**PLANNING PERMIT APPLICATION**  
**Planning & Building Department**  
**Planning Division**

Name/Description: Westview Townhomes

Enclosed please find the Westview Town Home geotechnical report with an errata addressing George Machan/Landslide Technology comments. Please let me know if you have any questions.

JG has prepared this Errata and Commentary (E&C) in response to the technical aspects of the review and letter from LT. This E&C is hereby incorporated into the Geotechnical Report and should accompany the report in all future submittals and correspondence.

Figure 1: Boussinesq Vertical Stress Distribution below Continuous Footing

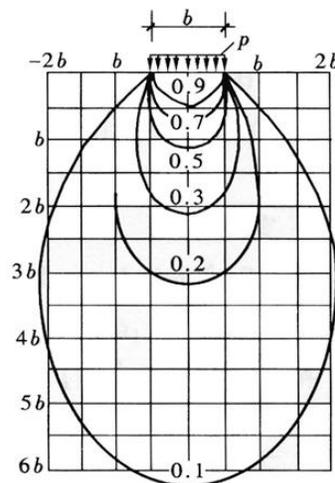
- 1) Section 6.1.3, page 26  
Pressure Distribution under a Footing  
The correct distribution is “**1/2H:1V slope.**”

Although assuming foundation pressures induced on underlying soil follow a linear distribution of 0.5H:1V, often referred to as the "2:1 Method", it is not the only approach to estimate pressures applied to soil by foundation elements. Boussinesq stress distributions, based on elasticity theory, have more of a "bulb" shape. The figure below shows the pressure distributions for a strip footing of width =  $b$ . As is shown in the figure, a pressure equipotential line equivalent to 30% of the foundation pressure ( $0.3p$ ) extends to an approximate depth of  $2b$ , commonly referred to as the foundation's "zone of influence", and only extends laterally to approximately  $0.75b$  from the center of the footing. Therefore, in our opinion, requiring the excavation to extend the lateral distances suggested by LT is not necessary.
